AEOD TECHNICAL REVIEW REPORT

UNIT: Oconee 1, 2, and 3
DOCKET NOS.: 50-269, 50-270, 50-287
LICENSEE: Duke Power Company
NSSS/AE: B&W(Utility/Bechtel)

TR REPORT NO.: AEOD/T928
DATE: December 20, 1989
EVALUATOR/CONTACT: S. Salah

SUBJECT: INADEQUATE OVERPRESSURE PROTECTION FOR AUXILIARY STEAM HEADERS AT THE OCONEE PLANTS

FIGURE 1. STEAM FLOW PATH TO EMERGENCY FEEDWATER PUMP TURBINE (EFWPT)

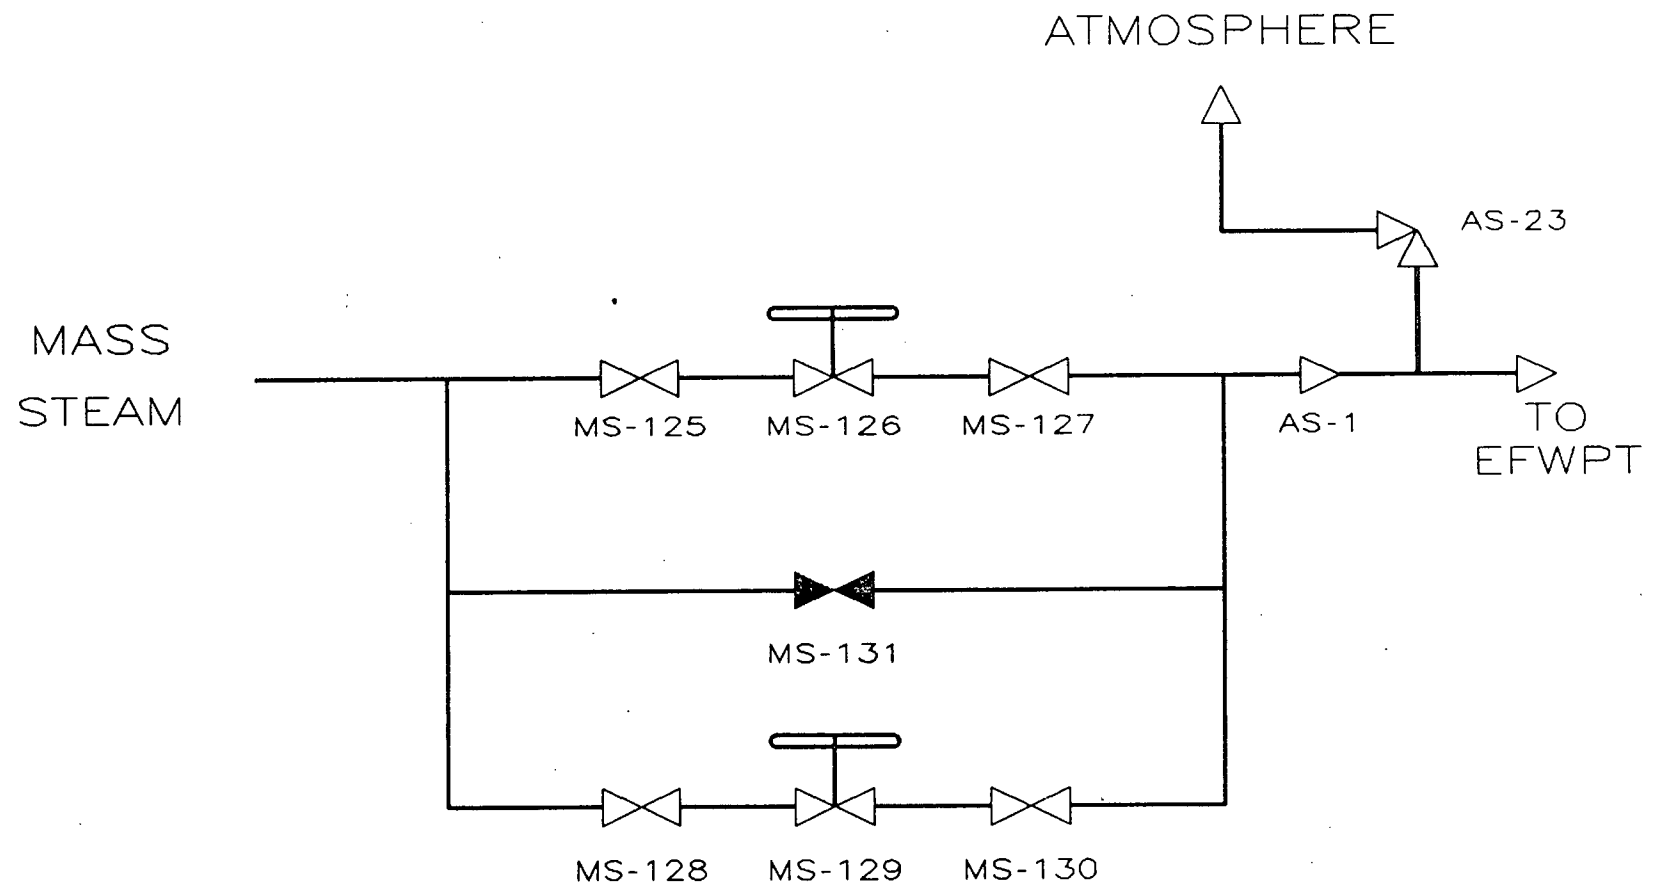
The safety concern was that the 4" steam header safety valve (AS-23) with relief capacity of 5.0E+04 lbs./hr was too small to provide overpressure protection, consistent with the requirements of Section VIII of the ASME Code, in the event both control valves MS-126 and MS-129 were to fully open owing to an erroneous control signal, or in the event that manual bypass valve MS-131 were fully open during a design basis event. A design basis event is any event that causes the steam generator pressure to reach the first set of safety valve set pressures of 1050 psig.

The licensee analyzed the adequacy of the safety valve (AS-23) on the steam line to the EFWPT during a simulated design basis accident. The results indicated that the potential for overpressurization existed in the event control valves MS-126 and MS-129 are given an erroneous signal to fully open. Therefore, during a design basis event in which control valves MS-126 and MS-129 are wide open, the auxiliary steam header safety valve AS-23 was inadequate to keep the pressure below the limits specified in Section VIII of the ASME Code.

To permanently resolve this problem, the licensee has installed two additional 6" safety valves on the auxiliary steam header downstream of control valves MS-126 and MS-129. Installation of the additional safety valves was completed in June of 1989 at Oconee Unit 2. Installation of additional safety valves in Unit 1 and 3 were completed earlier this year. Additional safety valves will adequately take care of possible overpressurization problems during a design basis accident even with control valves MS-126 or MS-129 wide open.
